## NOTICE OF DECISION

**PARTITION CASE NO.:** PAR20-08

**REQUEST:** A tentative partition to divide 0.65 acres into three parcels, with Parcel 1 consisting of approximately 11,666 square feet, Parcel 2 consisting of approximately 5,541 square feet, and Parcel 3 consisting of approximately 7,416 square feet. The existing single-family dwelling would remain on Parcel 1, and parcels 2 and 3 would consist of vacant land for future development. The subject property is zoned RS (Single Family Residential) and located at 655 Boone Road SE (Marion County Assessor map and tax lot number(s): 083W10CD / 04400).

**LOCATION:** 655 Boone Road SE, Salem OR 97306

SHEET  
1/1

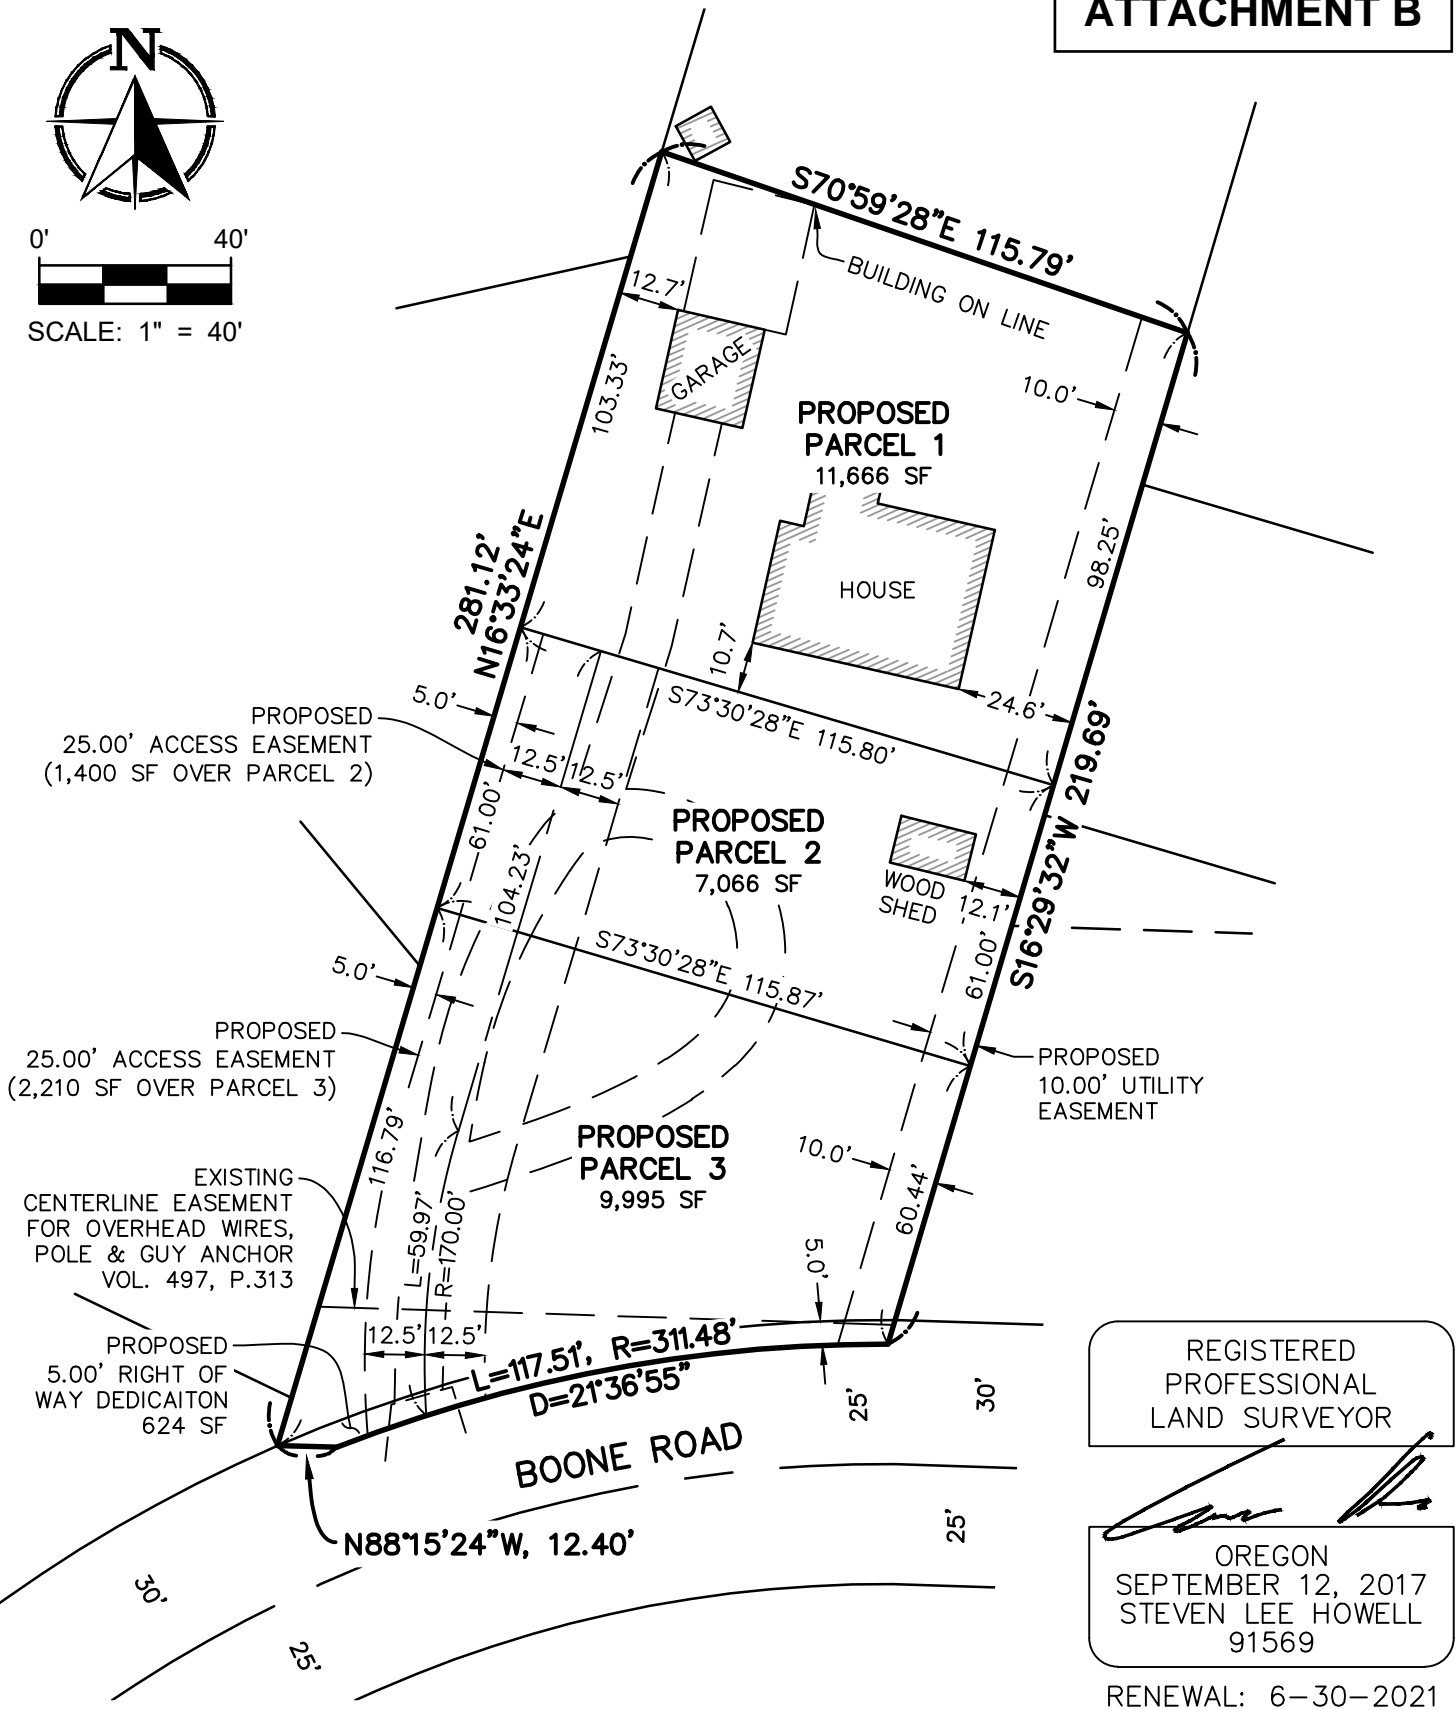
**Staff Response:** The existing and proposed use, *single family*, is permitted within the RS zone. However, the proposal would locate the existing wood shed on its own parcel. A standalone wood shed, classified as a *warehousing and distribution* use, is a prohibited use within the RS zone. To ensure the proposal does not create a nonconforming situation, the following condition of approval shall apply:

As stated above, the applicant plans to remove the existing lean-to adjacent to the detached garage. To ensure the proposed development meets the setback standards of the RS zone, the following condition of approval shall apply:

**Staff Response:** The existing single-family dwelling's garage is served by a gravel driveway. The applicant's site plan (**Attachment B**) shows the portions of the gravel driveway which pass over proposed parcels 2 and 3 will be replaced with pavement to meet the flag lot accessway width and surfacing standards of SRC 800.025(c). However, the site plan does not indicate that the existing gravel driveway on proposed Parcel 1 will meet the surfacing standards of this section. To ensure the proposed development meets the standards set forth in SRC 806.030(c), the following condition of approval shall apply:

**Condition 1:** Prior to final plat application, remove the existing wood shed from Parcel 2.

**Condition 2:** The applicant shall either remove the existing lean-to adjacent to the detached garage on Parcel 1, or provide evidence the lean-to meets the setback standards of the RS zone.

**Condition 3:** The existing gravel driveway on Parcel 1 shall be removed and replaced with a driveway meeting the standards set forth in Salem Revised Code 806.030, including that it be paved with a hard surface material meeting the Public Works Design Standards.
